PROPOSED DEVELOPMENT CONDITIONS

SE 2010-DR-019

July 26, 2012

If it is the intent of the Board of Supervisors to approve SE 2010-DR-019, located at Tax Map 6-1 ((1)) 18 (12218 Leesburg Pike) for a special exception to permit a fast food restaurant with a drive-through pursuant to Sect. 9-501 of the Fairfax County Zoning Ordinance, Staff recommends that the Board condition the approval by requiring conformance with the following development conditions:

Proposed Fence Location and Proposed Fence.

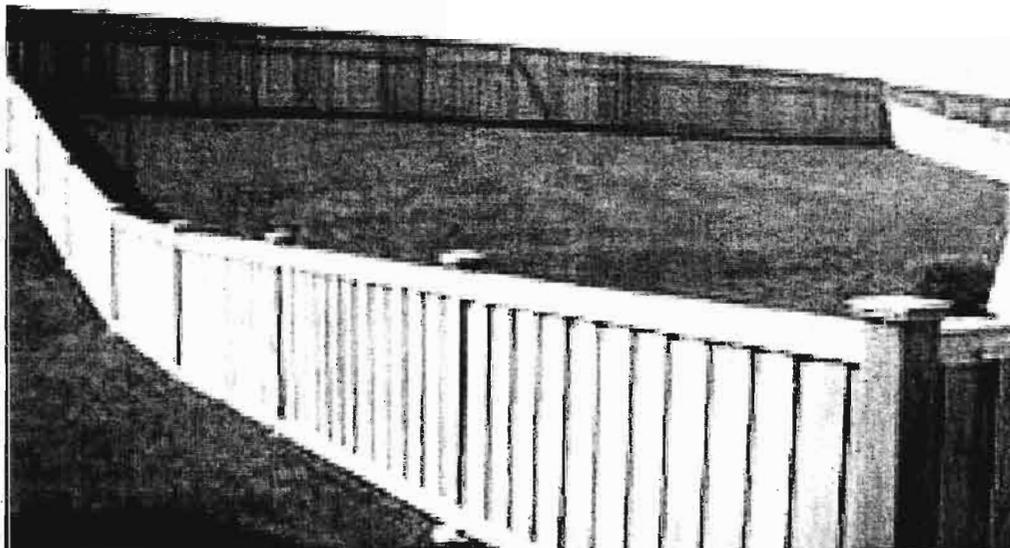
Proposed Fence Location (indicated in bold lines).

Proposed solid fence not to exceed four feet in height and being of a neutral, natural or earth tone color.
